**Response to Agency Comments on Civil Drawings and Report – The Next Generation, Energy from Waste Plant, Eastern Creek**

We have reviewed all the Agency Responses to the Environmental impact Statement (EIS) for the proposed Energy from Waste Facility in Eastern Creek. Find below a summary of our responses to all the Agency comments for all civil and storm water related queries.

# **SSD 6236 – Energy from Waste Facility Memo from Blacktown City Council**

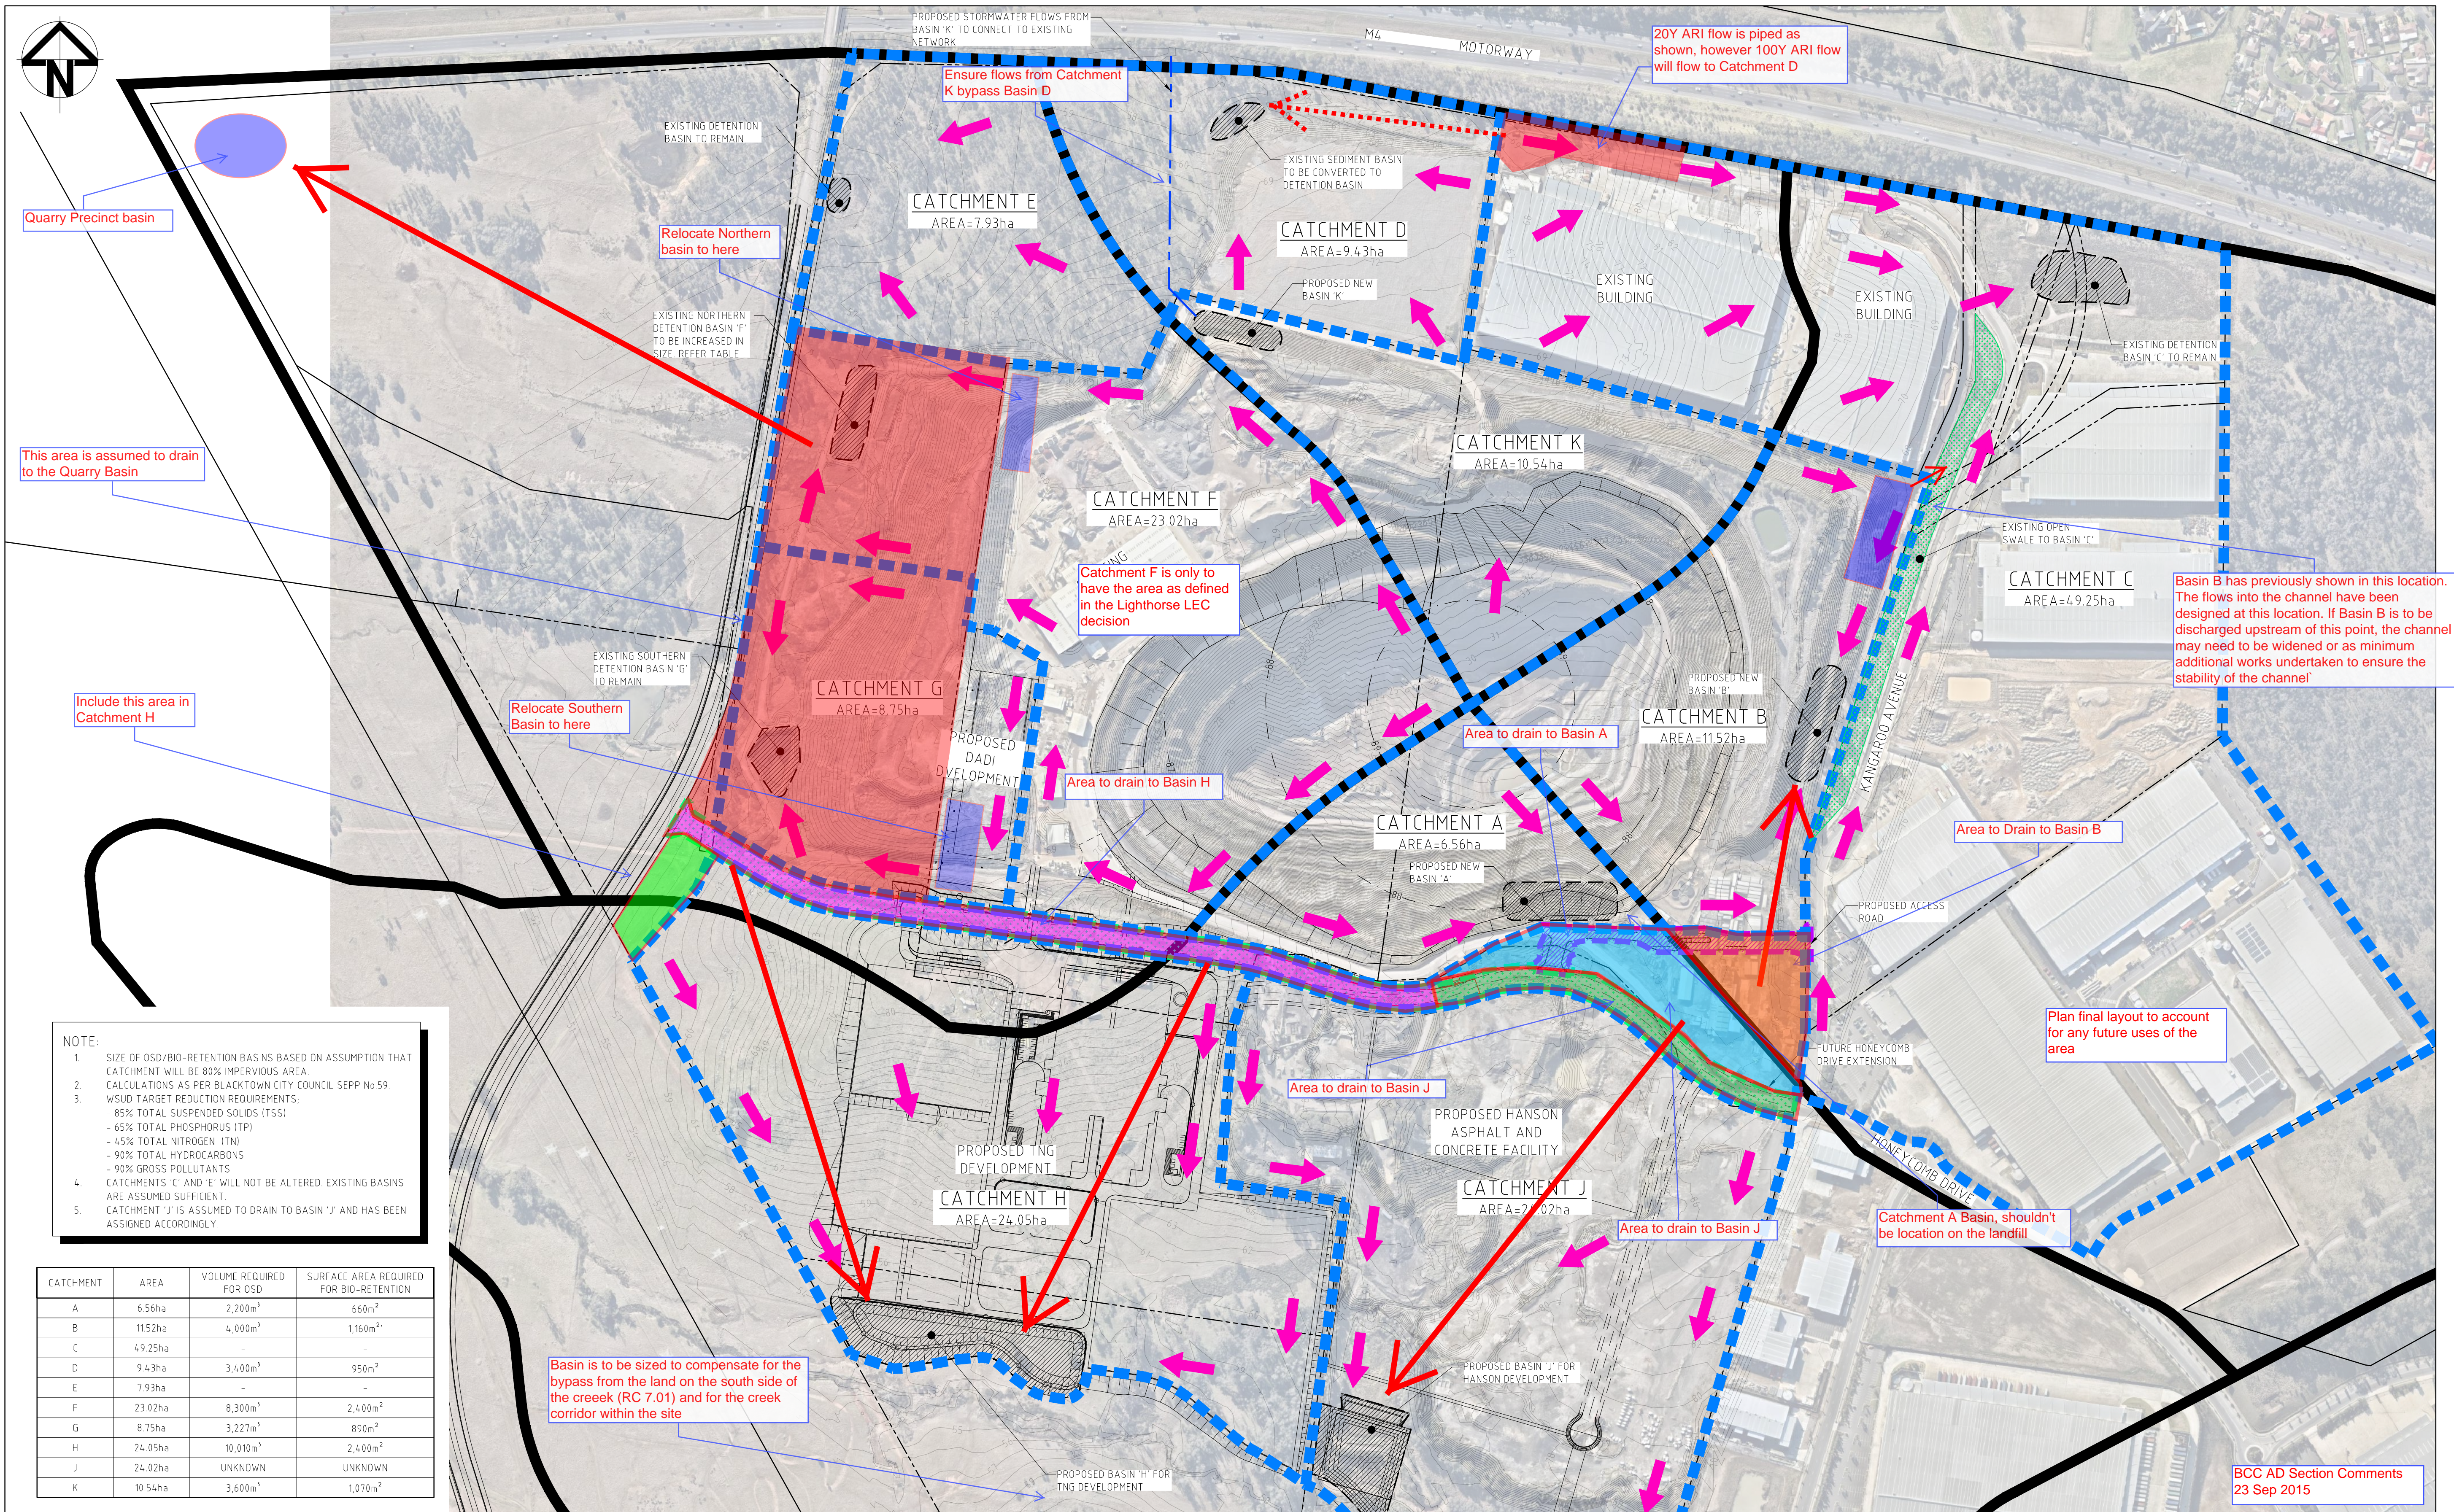
The report states that overland flows through the site have been designed to safely convey the flows, there is not enough information provided to assess the adequacy of this statement.

In addition an overland flow from the precinct road needs to be directed through the site, to the precinct basin.

**AT&L Response:** A DRAINS file has been provided to Blacktown City Council which models all overland flows from verification.

**AT&L Response:** This overland flow path has been provided and indicated in the current civil drawings

SKC007

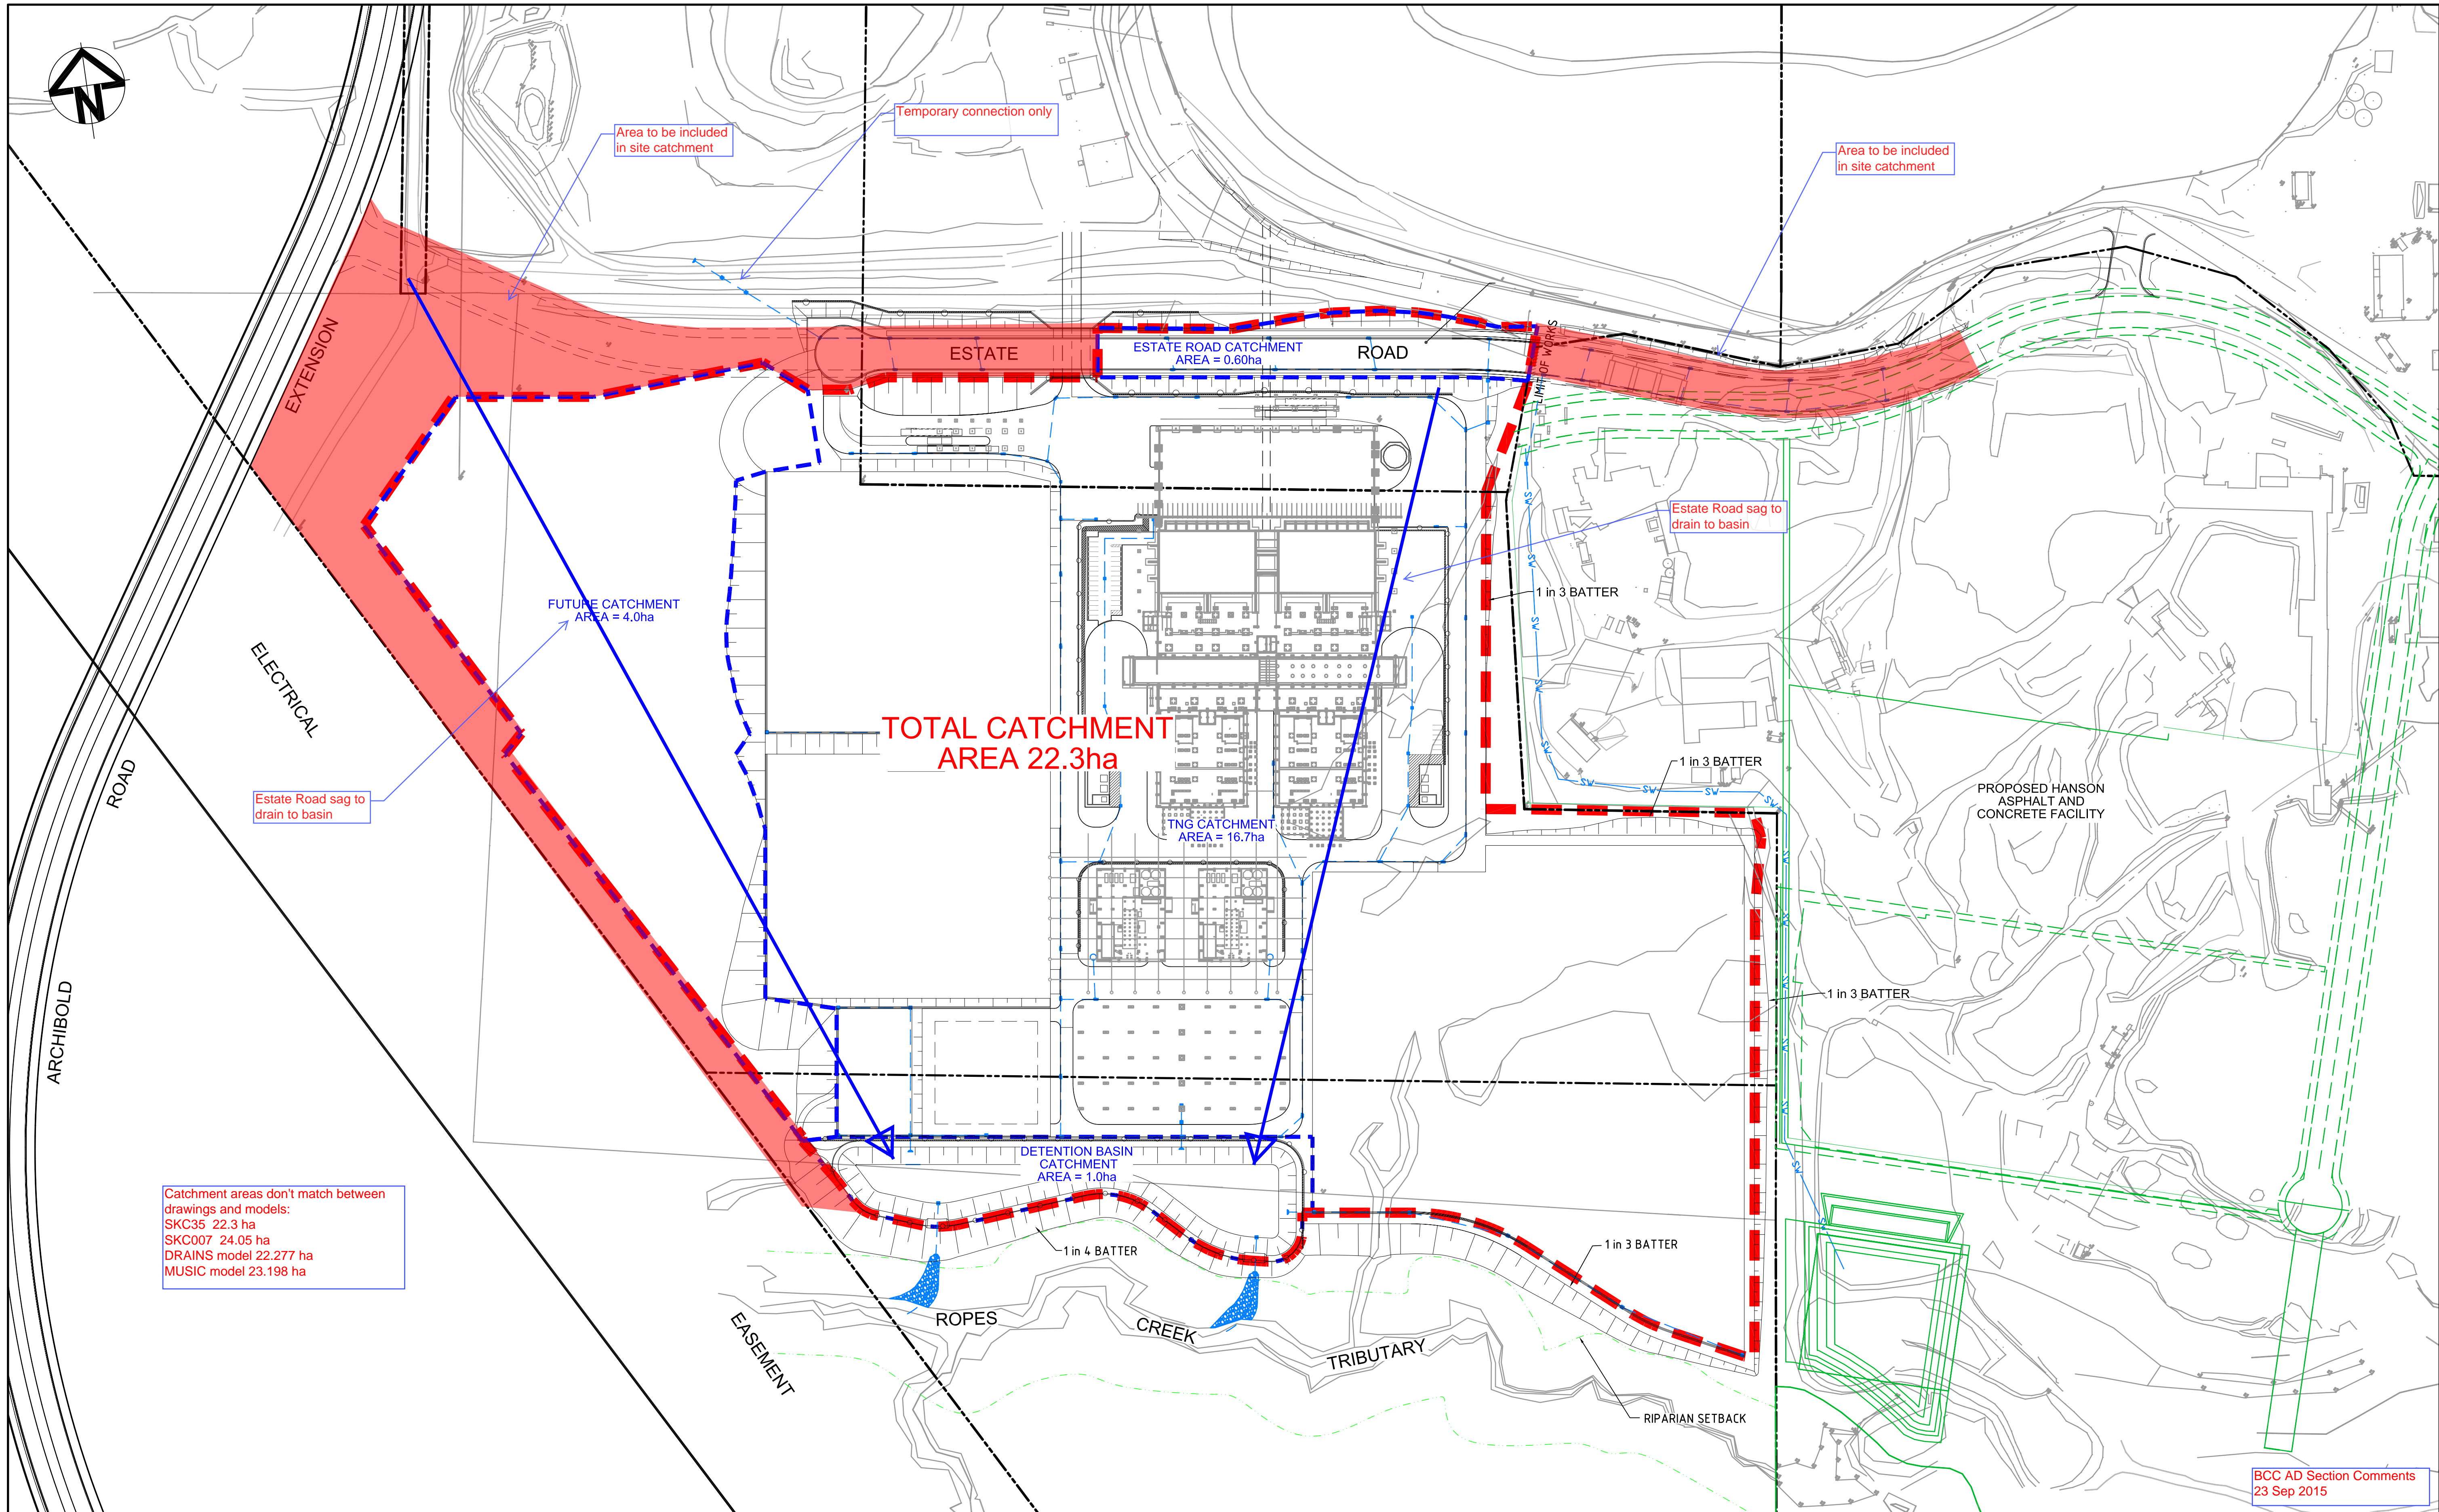
The proponent's engineer has prepared a catchment plan for the future stormwater management of the DADI site, as required by a LEC decision. Generally, this is in accordance with Council's catchment plan, referred to above. A marked up copy of this plan is attached and summarized below:

- Basin H provides detention not just for the site, but under the Precinct Plan also provides compensatory detention for the land on the southern side of the creek (catchment rc 7.01 in Council's catchment plan).
- Part of Catchment G is to be managed in the Quarry Catchment Basin. The existing basins need to be relocated to within the approved Lighthorse area.
- The overall stormwater management strategy should facilitate future development of the site
- There are areas in Catchments A and B that need to be managed prior to discharge.
- Basin B is to be located in the north east corner of the catchment. If it is located further up the channel, the channel may need to be widened to convey the additional flow or as a minimum additional works to ensure stability of the channel.

With the catchment plans and the models there are discrepancies in the total catchment areas:

- Drawing SKC007 24.05 ha
- Drawing SKC35 22.3 ha
- DRAINS model 22.277 ha
- MUSIC model 23.198 ha

These areas are to be corrected so that they are consistent.

**AT&L Response:** AT&L have produced a revised overall stormwater management plan which indicates the finished quarry catchment areas. The design of all overland flow paths will comply with the Lighthouse approval. This will be confirmed prior to Construction Certificate application.
